To: Auburn Planning Board
From: Megan Norwood, City Planner II
Re: North River Road (PID 271-101), Proposed 3, 12-Unit Apartment Buildings and associated parking, driveways, landscaping, utilities, & other site improvements in the General Business Zoning District (West Shore Landing Apartments).
Date: January 14, 2020

In-Lieu Fee Breakdown:

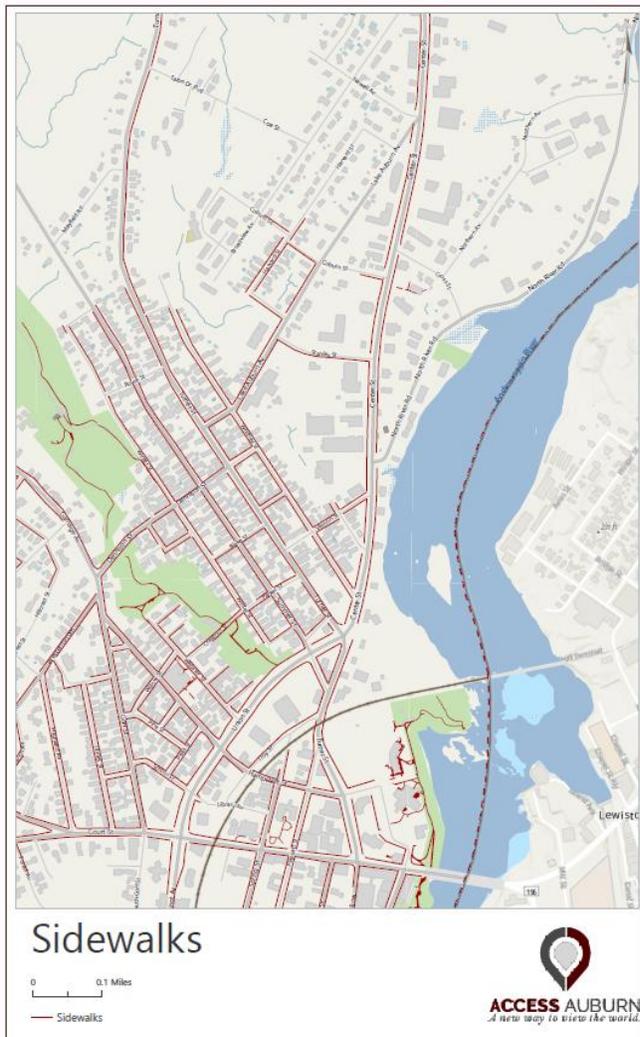
As the Planning Board is aware, Sec. 60-1367 requires open space at a rate of not less than 43,560 contiguous square feet or one acre of land for the first ten lots or units. The amount of land required is increased at a rate of 5,000 square feet per unit for each additional unit over ten units. For the 36 proposed units, the open space required would be 3.98 acres or 173,560 square feet. The parcel itself is only 3.3 acres. The Ordinance also allows the Developer to contribute a fee in-lieu amount in cash. The proposal includes 1.43 acres of open space and a fee in-lieu in the amount of \$34,000. The calculation is based upon the purchase price of the lot which was Staffs suggestion of how to calculate the fee in-lieu (breakdown below).

- *The ordinance requires 1 acre for the first 10 units and 5,000 square feet for each unit over 10 units, for 36 units: **173,560 square feet of open space is required.***
- *The Developer is proposing to provide 62,288 square feet of open space on the site. Subtracting that from the amount of open space required: 173,560-62,288 = **111,272 square feet of open space required.***
- *The property is 123,959 square feet and was purchased for \$37,000. (**Purchase Price/Remaining Open Space Required**) (\$37,000/123,959) = **\$0.298486***
- *(111,272 square feet of open space required * \$0.298486 dollar value per square foot) = **\$33,212.13** – **The Developer is rounding this number up to \$34,000.***

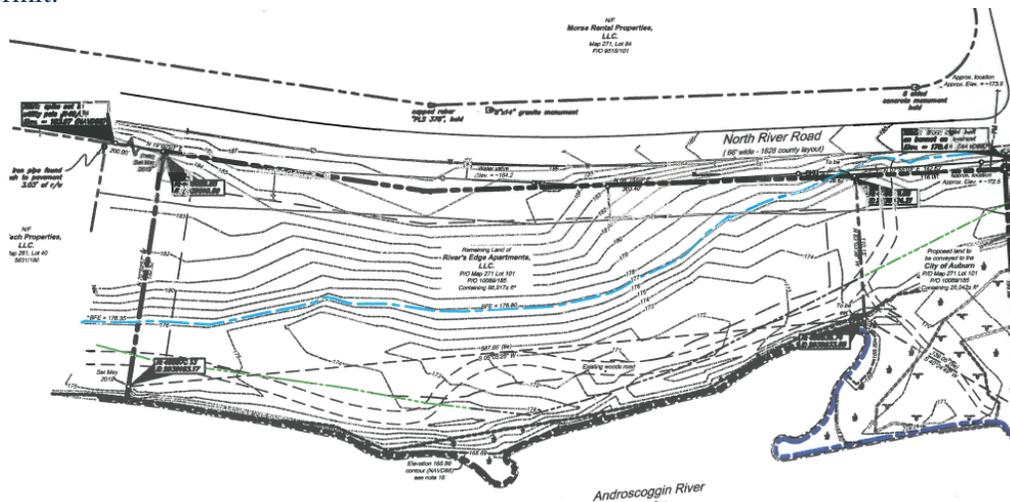
b. Several sections of the Shoreland Zone, Floodplain and Subdivision Ordinance have provisions for stormwater management and vegetation removal. Before moving forward with a Preliminary Plan approval, the Planning Board requested information be submitted on how stormwater will be handled at the project, and if any further vegetation is proposed for removal and/or restoration.

A Stormwater Management Report has been included in the more recent packets. It has been reviewed by the Engineering Department for compliance with the ordinances and State requirements and it meets the requirements. As discussed in the Stormwater Management Report, the paved parking, walkways and lawn areas are designed to direct stormwater towards two underdrain soil filters (UDSF), it is proposed to flow overland and through closed drainage systems in the parking areas to the two UDSFs. The report also includes

a site-specific Erosion and Sediment Control Plan and Inspection and Maintenance Plan of the Stormwater Management Facilities.

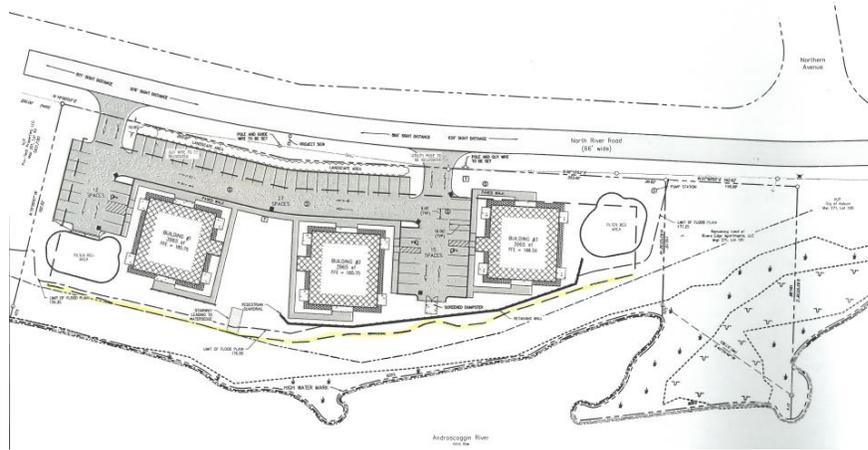
1. Recommend the 25-foot stream setback and normal high-water mark for the building, parking areas and retaining wall be delineated on the final plan.

The high-water mark has been delineated on the plan. The setback line along the water is the shoreland zone setback. The Developer met on site with DEP and determined that the line be measured from the top of the bank (slopes greater than 3:1) rather than the mean high waterline. All structures and parking areas are proposed to be located out of this setback (see highlighted area below for the setback in relation to building and parking areas).

Measuring Building Height
(figure 1)

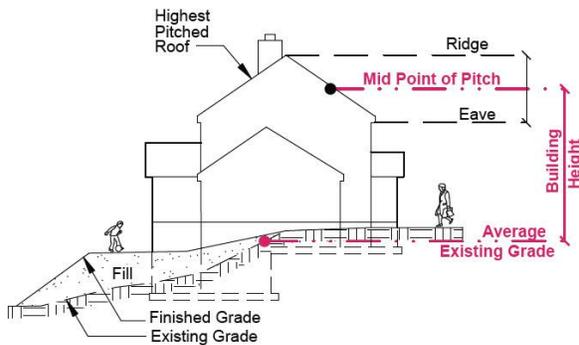
2. Review the building height to ensure it complies with the ordinance requirements as discussed in the Staff Report.

accessory structures...shall not exceed 35 feet in height...” Because of this, it is Staffs interpretation that regardless of the Shoreland district a project is located in, it has to meet the 35-foot height requirement set forth for all projects in the Shoreland Zone.

Staff has used the “mean of the gable” for building height measurements in the past. It is a common architectural standard that is not spelled out in the ordinance which allows some latitude with the need for steeper pitches for Maine winters and for matching local character. Staff recommends a condition of approval that project meets the 35-foot building height requirement using the mean of the gable as the measurement.
